SUBMITTAL IDENTIFICATION SHEET

WEBSTER UNIVERSITY ISB
PROJECT NAME

055113-006
CONTRACTOR / CM SUBMITTAL NO.

RE: Stair #3 Shop Drawings

STRINGER SIZE C12 X 20.7

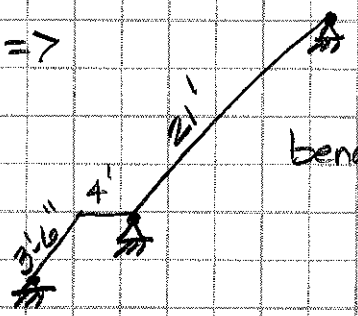
check weld $\frac{14.3 \cdot 12000}{12.3} = 4766\ \#/in$

capacity quick check for 1/4" weld

0.928 · 4 = 3.712 k/in > 4.74 k/in

Standard fillet No Good

CJP Groove welds provided, ∴ OK

ONE BENT PLATE 12E

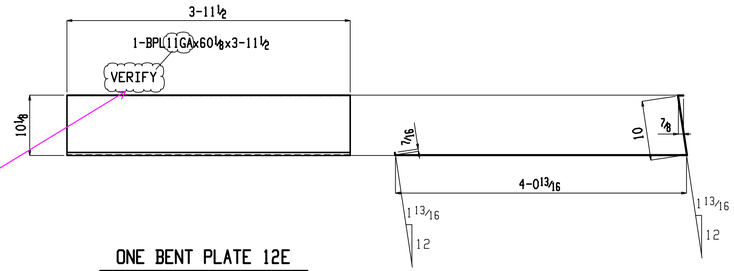
DELEGATED DESIGN, THICKNESS TO MEET PERFORMANCE REQUIREMENTS PER SPECIFICATION.

22 BENT PLATES 12D

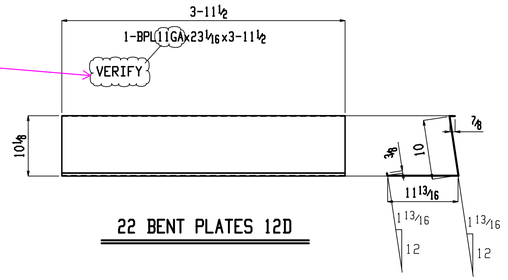
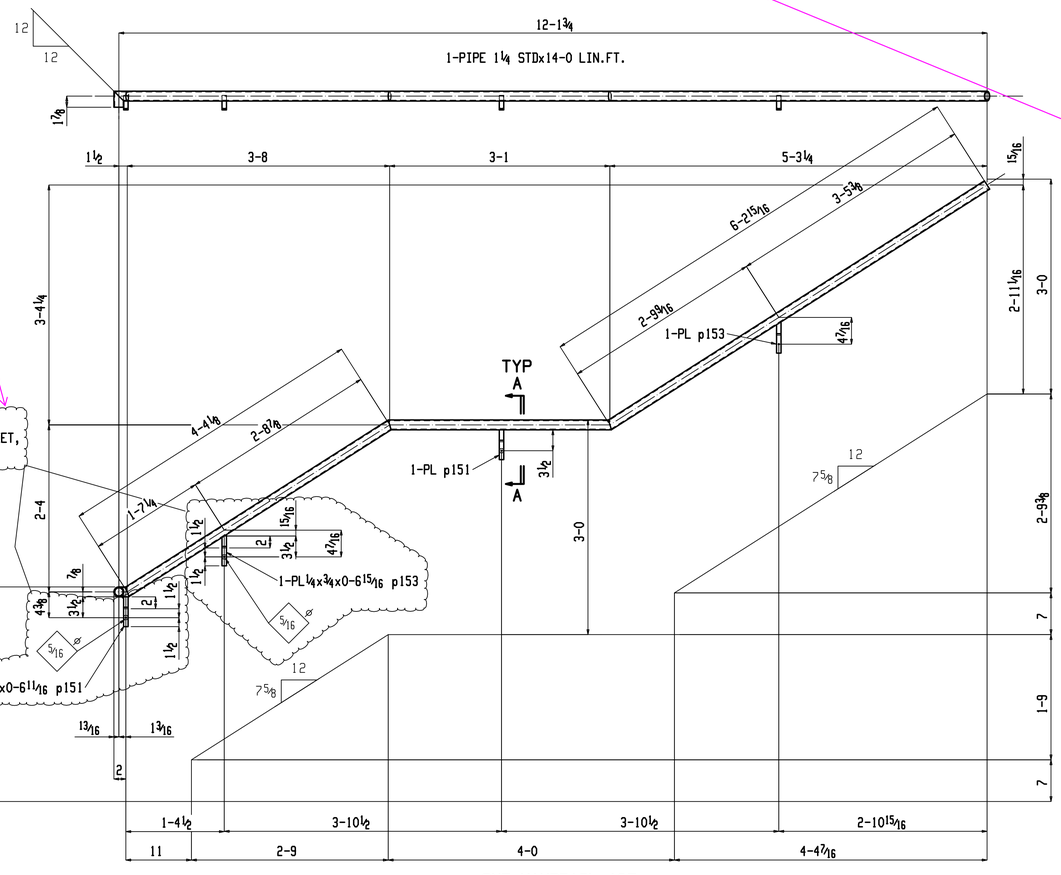
ACCEPTABLE, PROVIDED IT MEETS PERFORMANCE REQUIREMENTS PER SPECIFICATION.

APPROVER VERIFY OR PROVIDE HANDRAIL BRACKET, VERIFY ANCHORS
